ADDENDUM

Project Name: Elevator Modernization at: Lampe Hi-Rise (IL 16-4)

Addendum Number: 2

Issued: 05/08/2019

N O T E
ALL INFORMATION ON THIS
SHEET REPRESENTS EXISTING
CONDITIONS

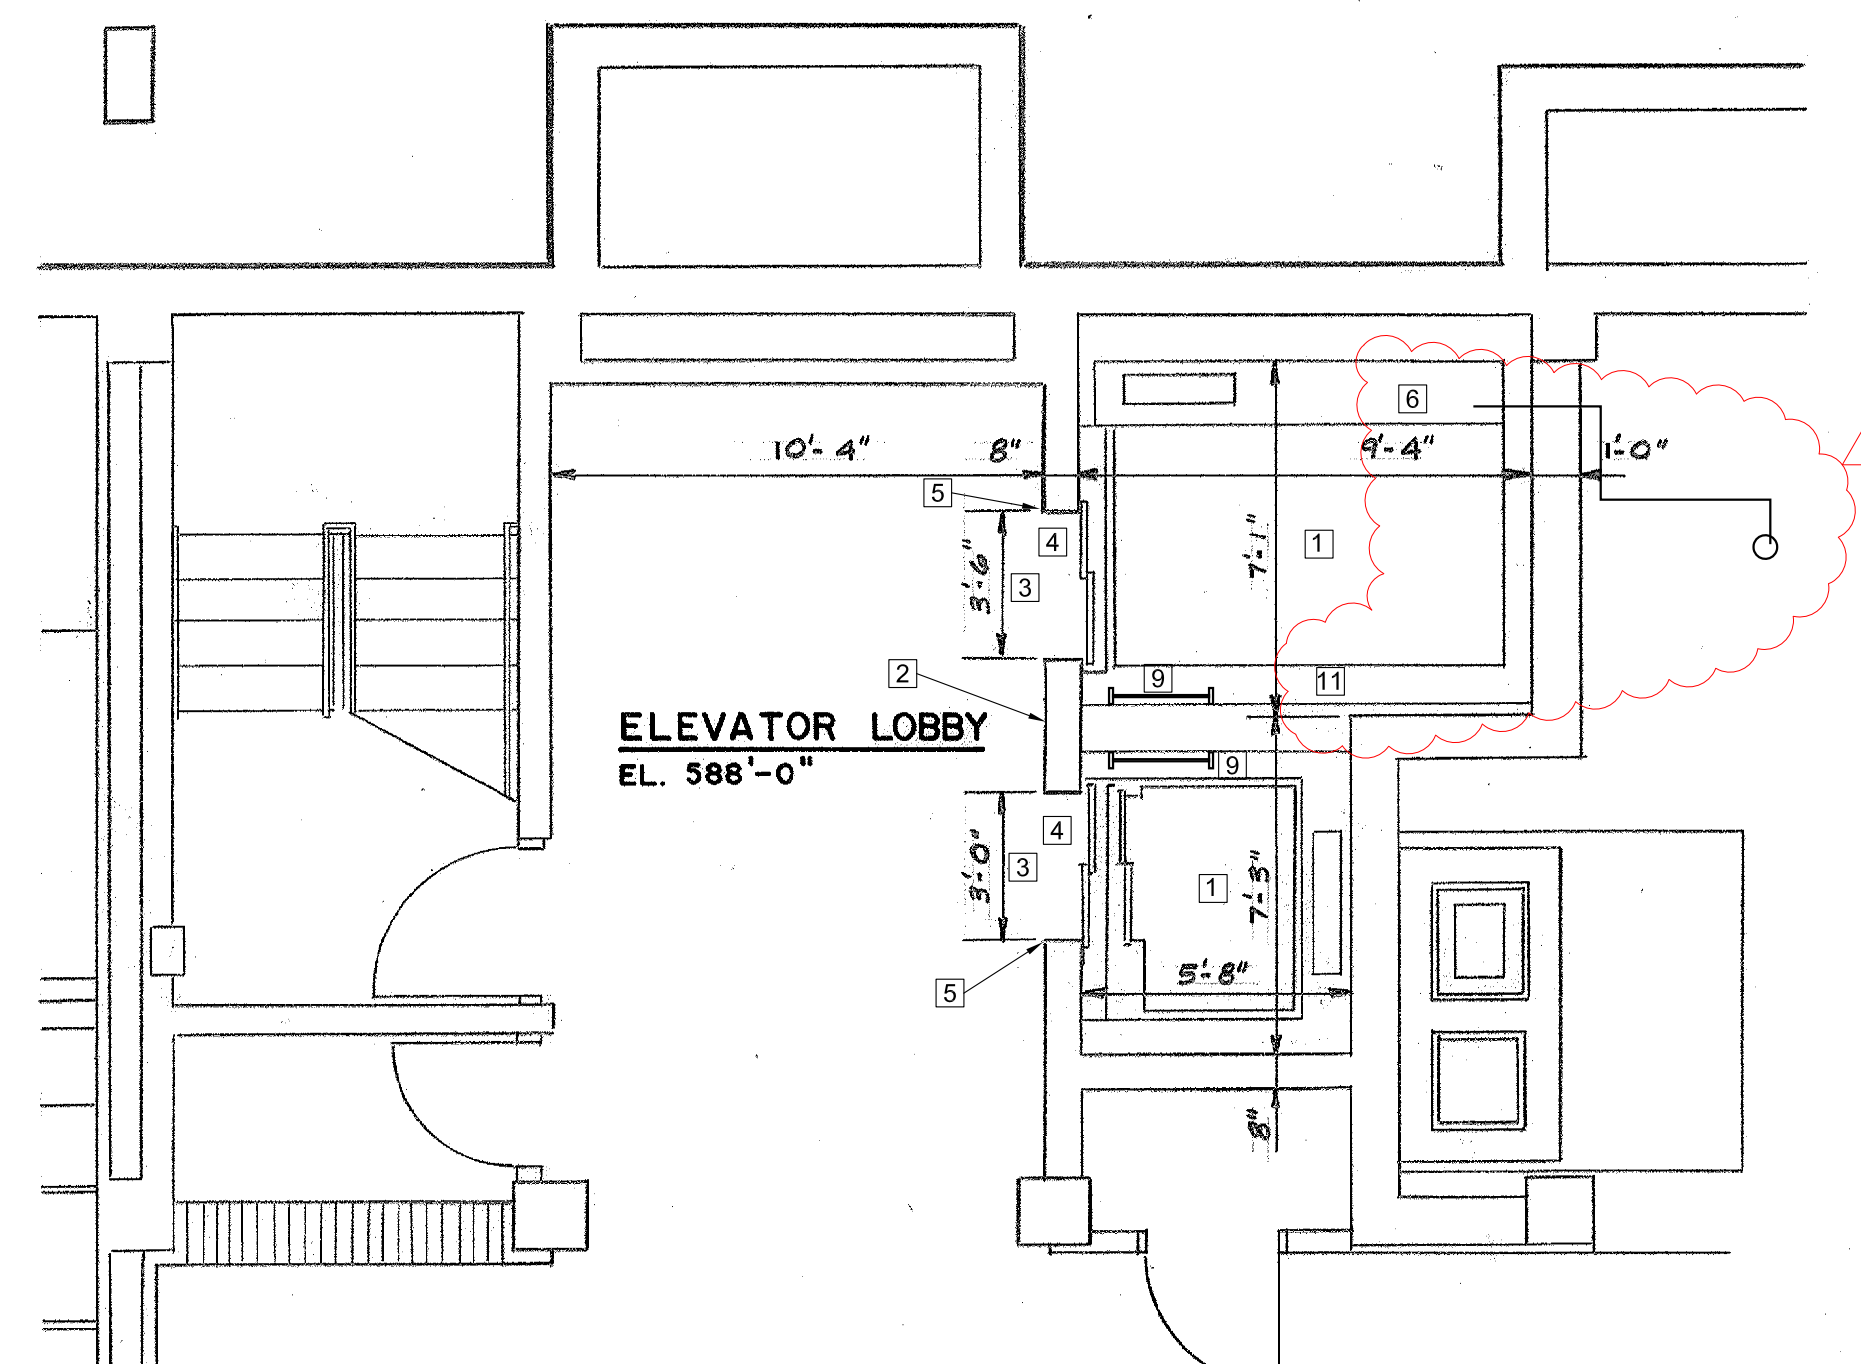
ITEM	DESCRIPTION	NOTES
SPECIFICATIONS:		
Form of Bid	Revise	Any products not otherwise listed shall be considered as an acceptable substitute under Alternate Bid "A-2". Contractor shall include a list of all proposed substitutions as well as the overall addition or deduction to the Base Bid price on the revised Form of Bid.
Section 14210 (2.02) (A)		
Section 14210 (2.02) (B)		
Section 14210 (2.03) (A)		
Section 14210 (2.04) (D)	Clarify	Communications systems and data line work shall be by the Base Bid "A" contractor.
Section 14210 (2.06) (A)	Clarify	Exterior side of door to be hand-painted in the field.
DRAWINGS:		
A101	Clarify	Electrical lighting fixtures and switches in elevator pit to remain.
A101	Clarify	Base Bid "B" contractor to provide new sump pump in existing pit. See revised Dwg. A101.
